**METROPOLITAN GOVERNMENT OF NASHVILLE AND DAVIDSON COUNTY**

**STAFF RECOMMENDATION**  
**208 Mayfair Road**  
**September 21, 2016**

**Application:** New construction—addition; Setback determination  
**District:** Cherokee Park Neighborhood Conservation Zoning Overlay  
**Council District:** 24  
**Map and Parcel Number:** 10312020100  
**Applicant:** Brian Layton  
**Project Lead:** Melissa Baldock, melissa.baldock@nashville.gov

**Description of Project:** Application is to construct a screen porch at the rear of the building that requires a setback determination.

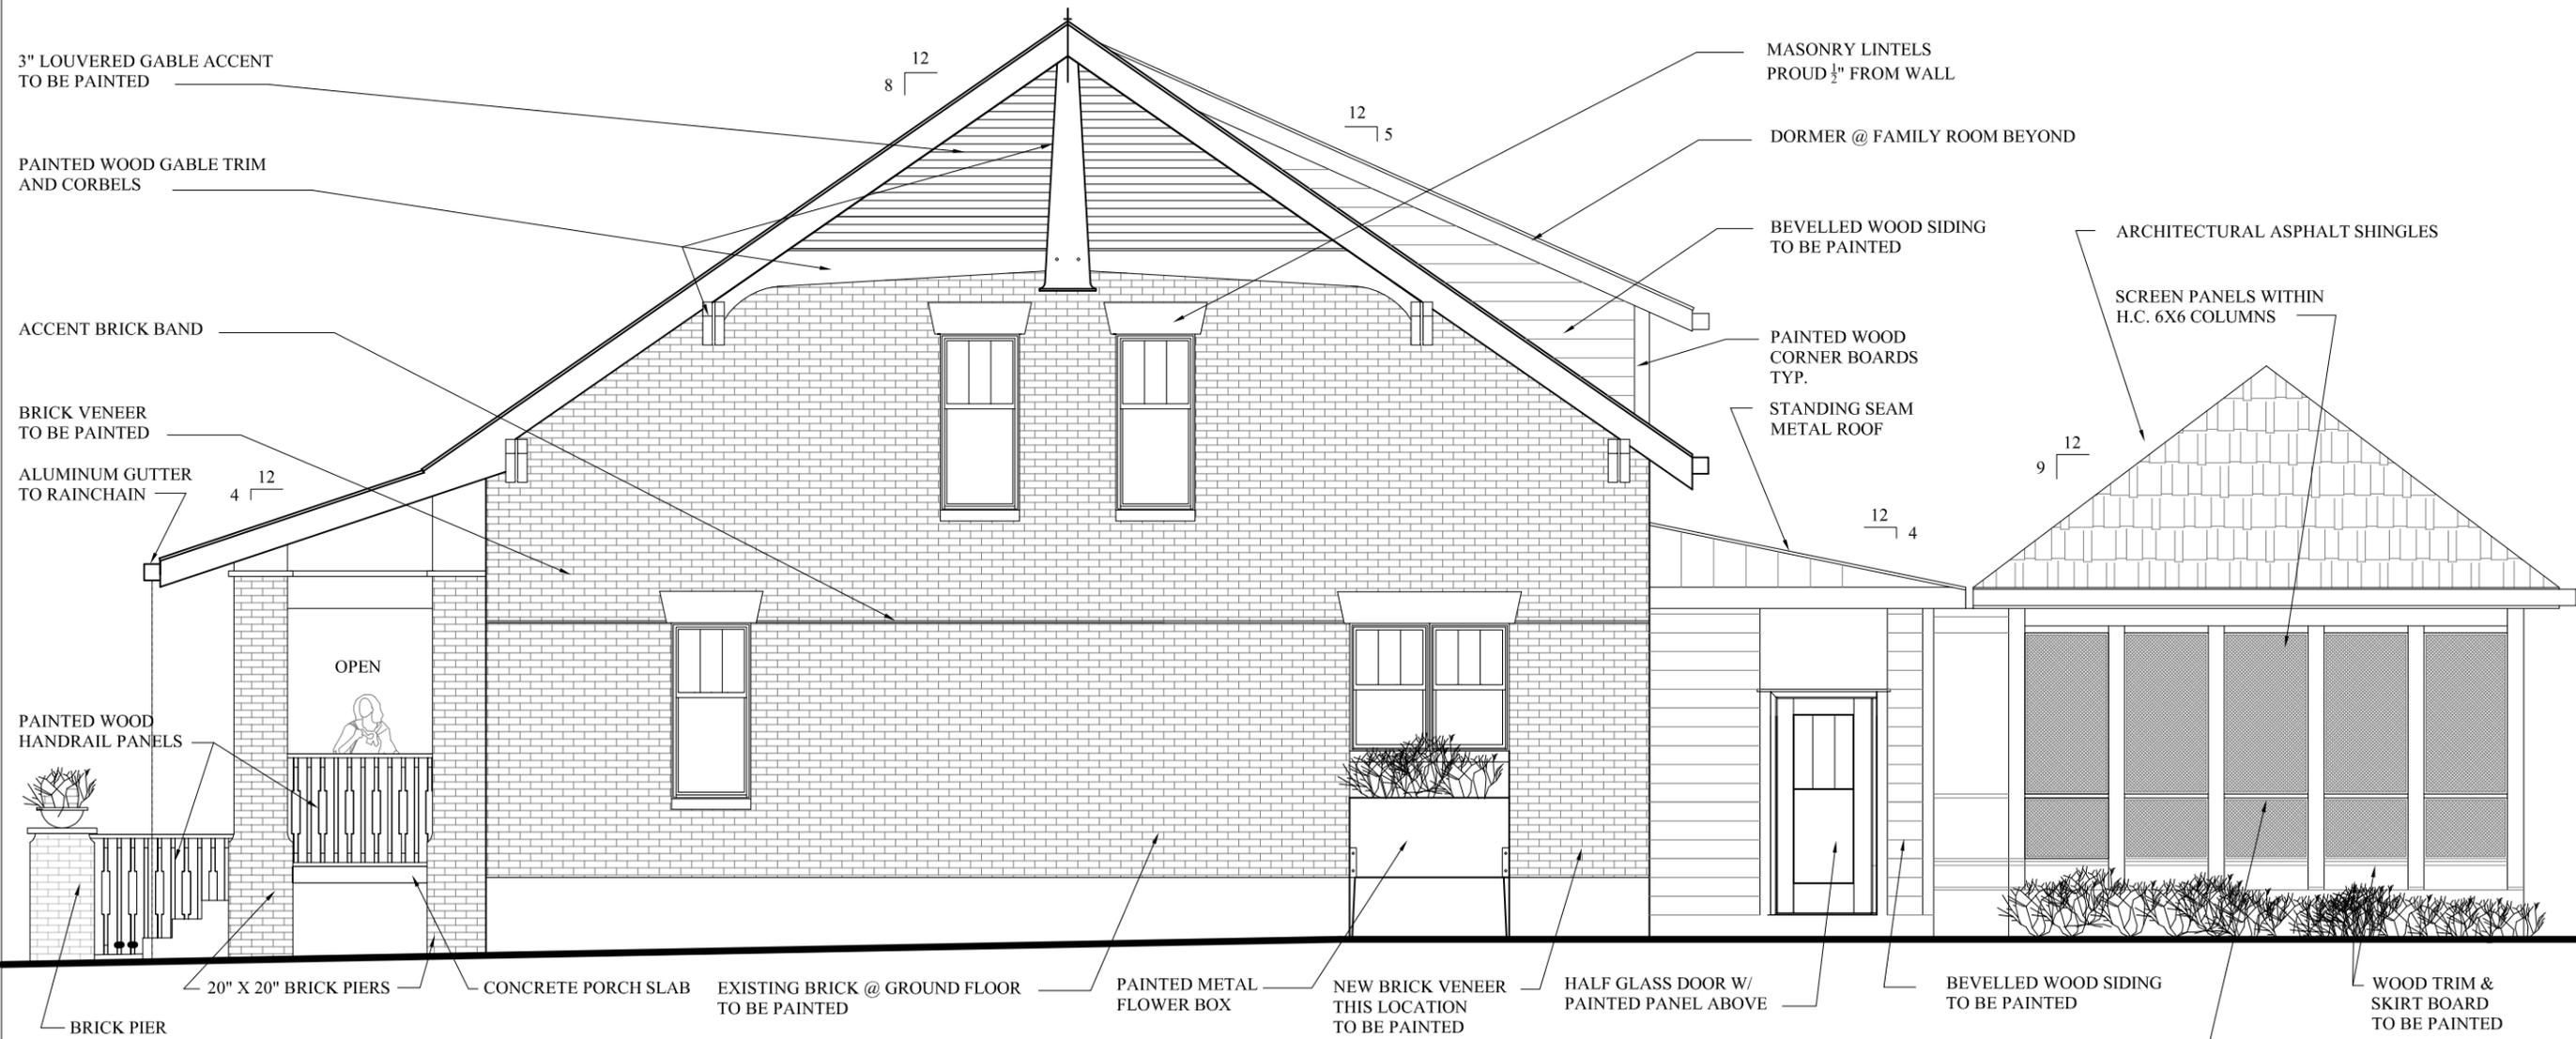
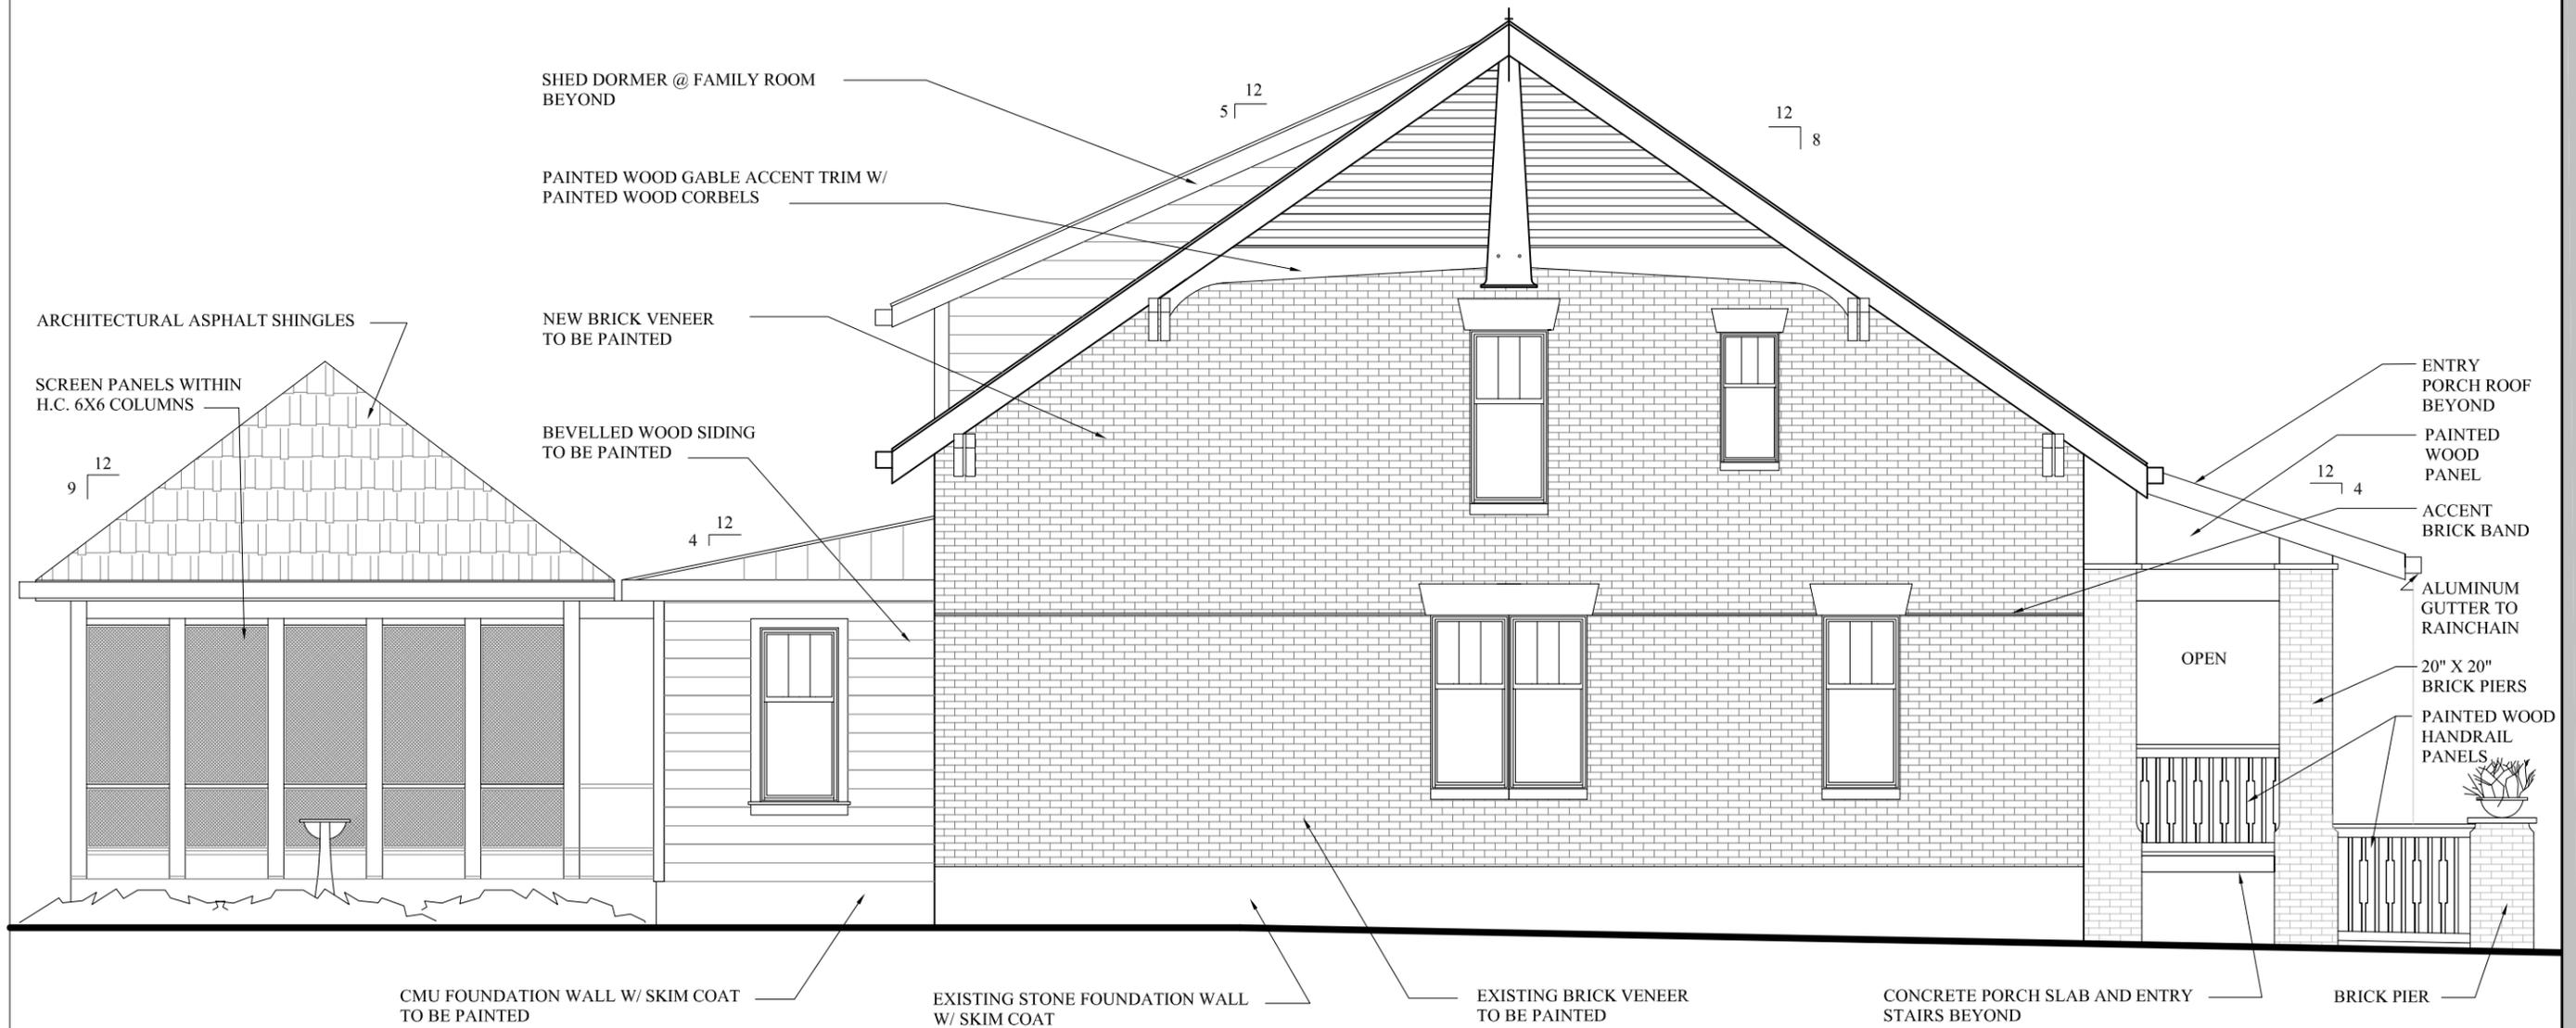
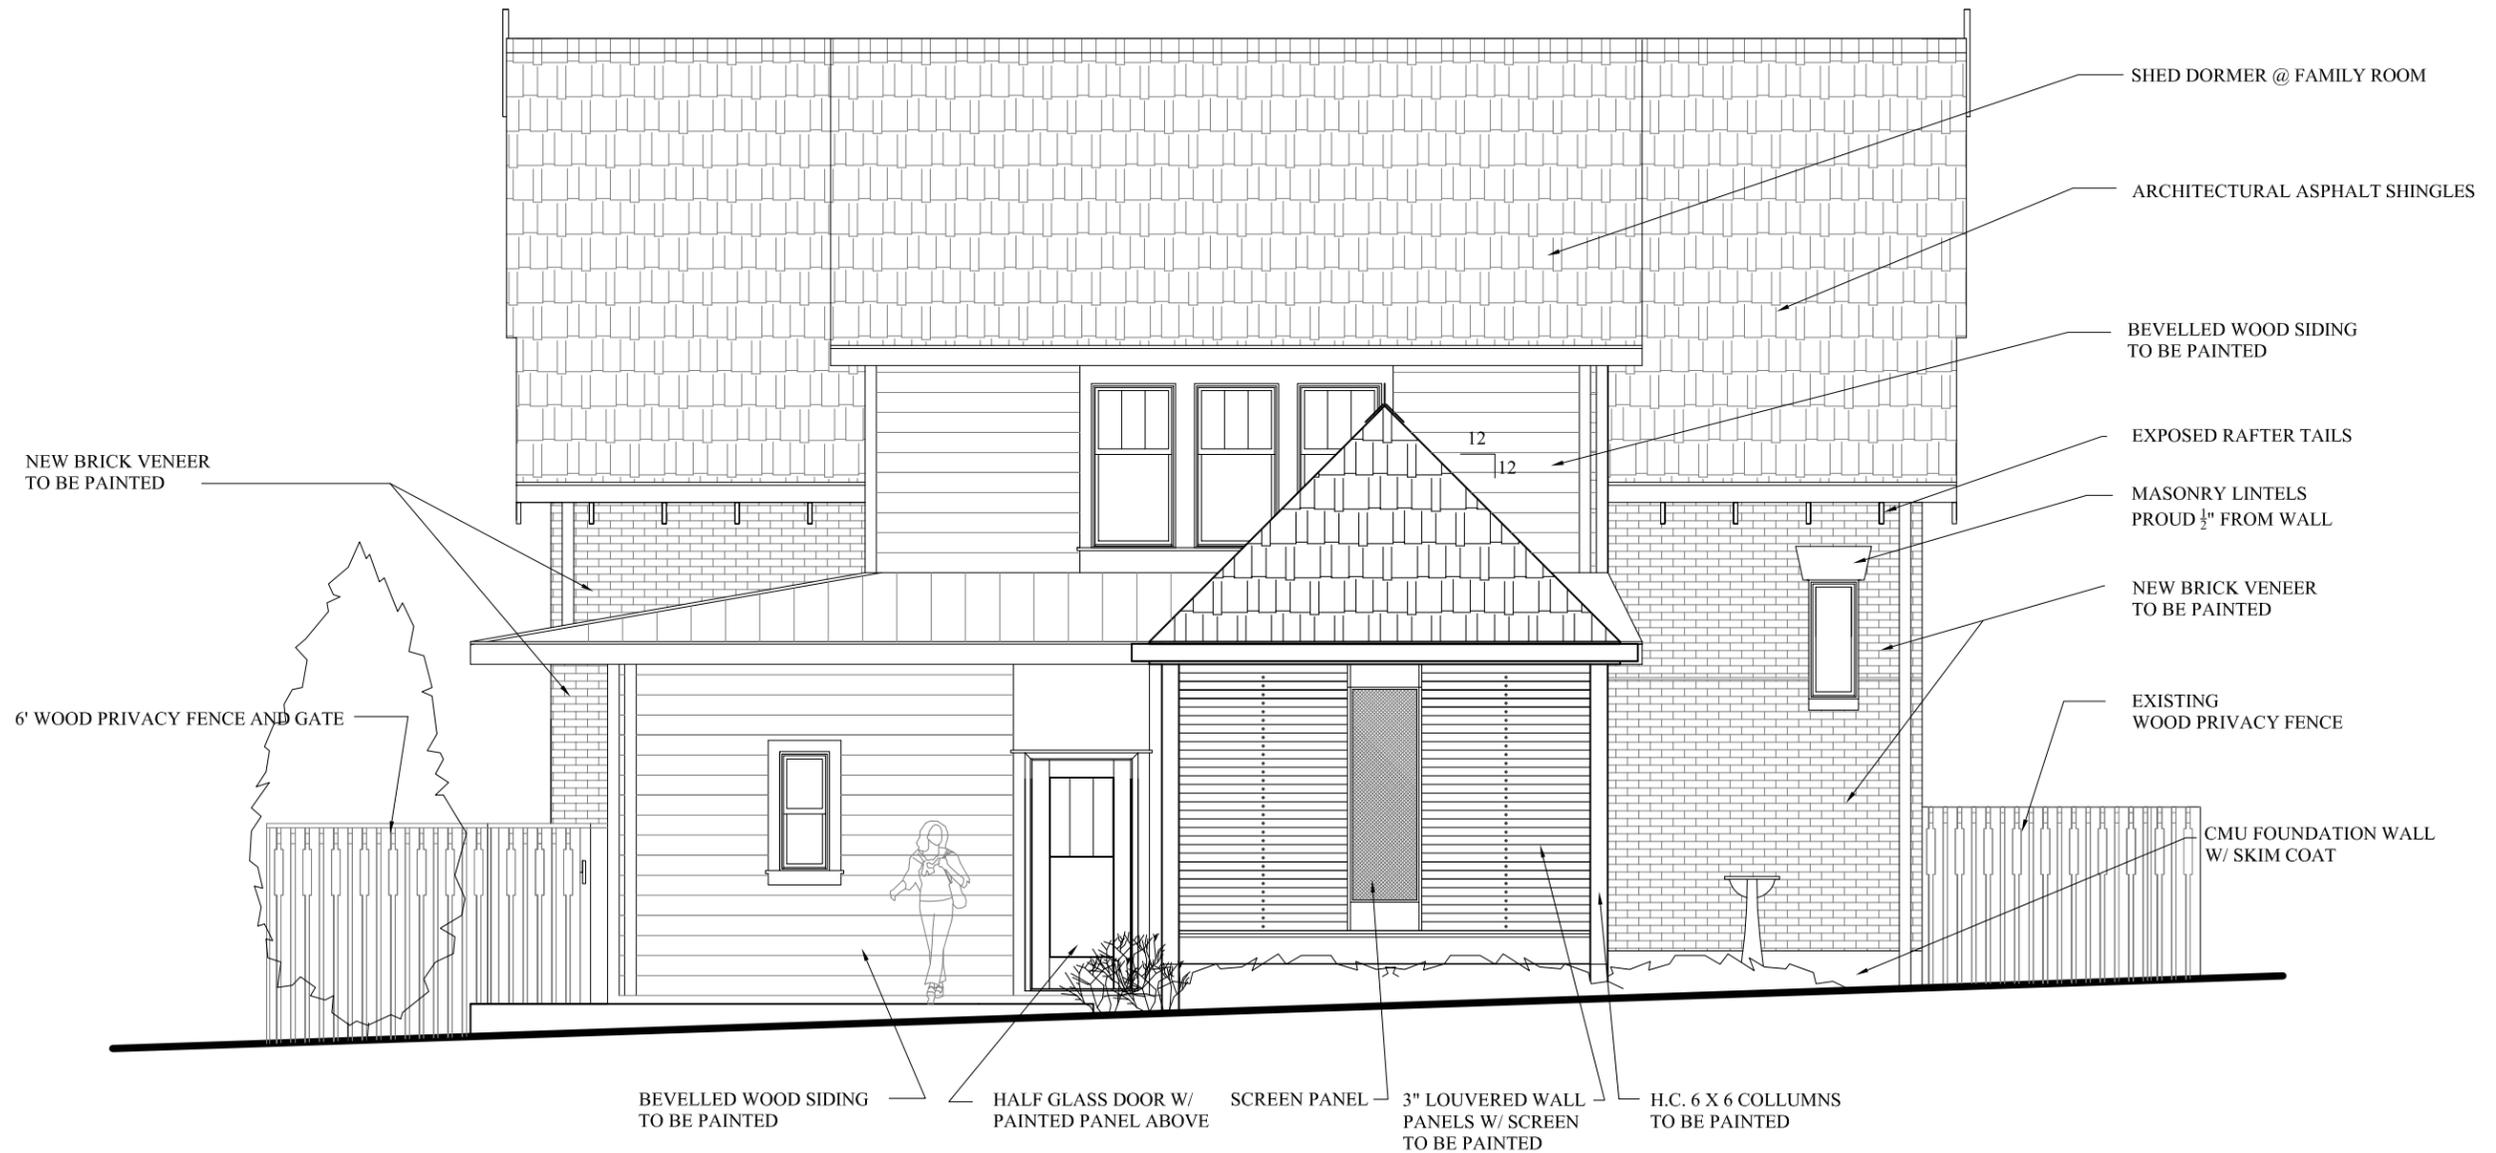
<b>Proposed</b>	<b>Color/Texture/ Make/Manufacturer</b>	<b>Approved Previously or Typical of Neighborhood</b>	<b>Requires Additional Review</b>
<b>Foundation</b>	Wood posts	Smooth	Yes	No
<b>Cladding</b>	Screens	N/A	Yes	No
<b>Secondary Cladding</b>	3” louvered wall panels (wood) – on rear	Smooth	No – but okay on the rear facade	No
<b>Roofing</b>	Architectural Shingles	Match existing house	Yes	No
<b>Trim</b>	Wood	Smooth	Yes	No
<b>Rear Porch Posts</b>	Wood	Smooth	Yes	No

Roof form: The rear porch’s roof form will be hipped with a 12/12 pitch. Staff finds that the roof form is compatible with the existing house’s roof form and with the historic context. Staff finds that the roof form meets Sections II.B.1.e. and II.B.2. of the design guidelines.

Proportion and Rhythm of Openings: The screen porch addition will largely be screened, which is appropriate. Staff finds the project’s proportion and rhythm of openings to meet Section II.B.1.g.
